Invitation of Public Comments

Sub: Permission for laying of 11 KV UG cable on NH-59 along from km 344/600 to 345/400 (Kamapali Chaka to MKCG Hospital) and km 345/600 to 346/300 (S.P Office to Bidyuthpur PSS) on LHS by TPSODL - reg.

INSPECTION REPORT

PROPOSED 11KV UNDER GROUND LINE FOR MEDICAL, BERHAMPUR, UNDER SDMF-II

Project	Proposed 11kv Under Ground Line for Medical, Berhampur, Under SDMF-II		
Client	TPSODL		
Title	SLD, NHAI		
Drp No.	SLD/TPSODL/GA/BHAMARPUR/001		
Date - 16.01.2025	Rev Date -	CHKD.	A.K. Nissanko
Scale - NTS	Rev No. - 00	DSGN.	A.K. Nissanko
	Sheet No. - 01	DRAWN	K. Sendha

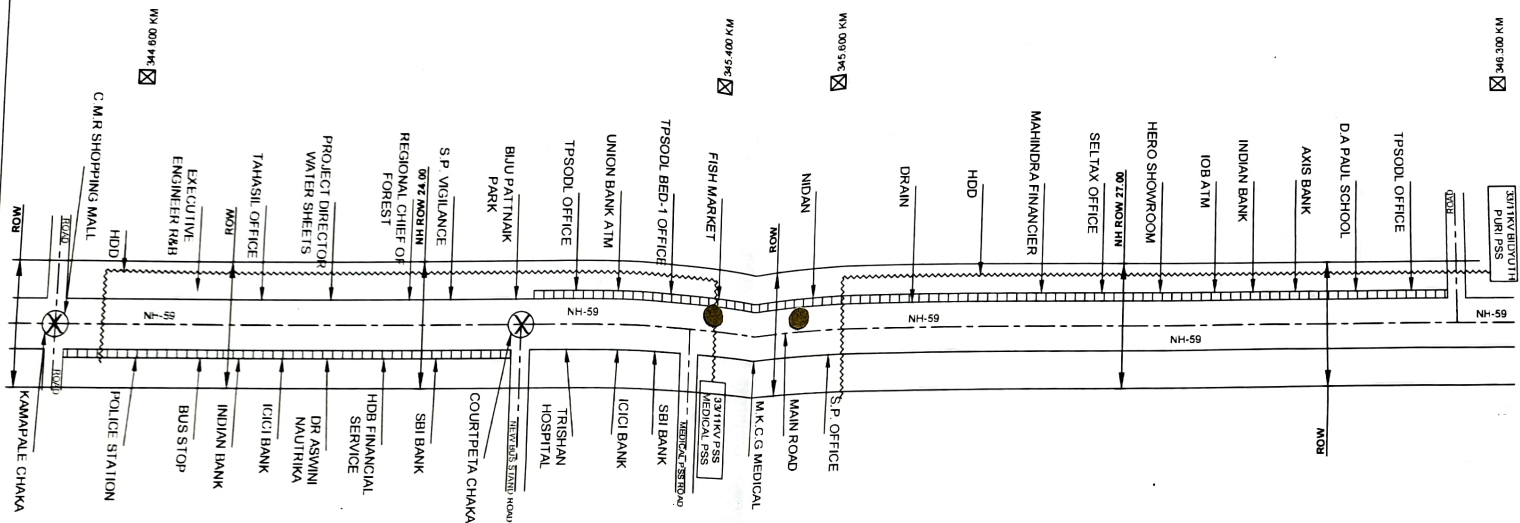
1. From Kamapali Chaka to MKCG Medical (Km 344.600 to 345.400 Km) and S.P. Office to Bidyuthpur PSS (345.600 to 346.300) of NH-59 comes under the Municipal area of Berhampur town. This stretch is having ROW varying from 27 m to 24 m. The lane configuration of the stretch and is having 4 lane (2 lane-2way having 14.00 m width) with median in the centre of the road. At maximum places of the stretches are constructed of RCC drains beside of the BT road so there is no space balance in between the BT road and in very recent past 80mm thick paver blocks are laid where space is available for road users. So for laying of UG cable by HDD method as proposed in the proposal will result in excavating of pit pit adjacent to BT road surface which will damage the laid paver blocks/BT road which should be restored to the original shape after completion of laying work.

2. The pit size should be Length= 2.10, Width=0.80 and Depth=0.60 m and at a distance of 230 m centre to centre for laying of UG cable by HDD method as mentioned in the drawing.

5. If any road crossing is involved the crossing should be done only by HDD method with encasing at proper depth from FRL.
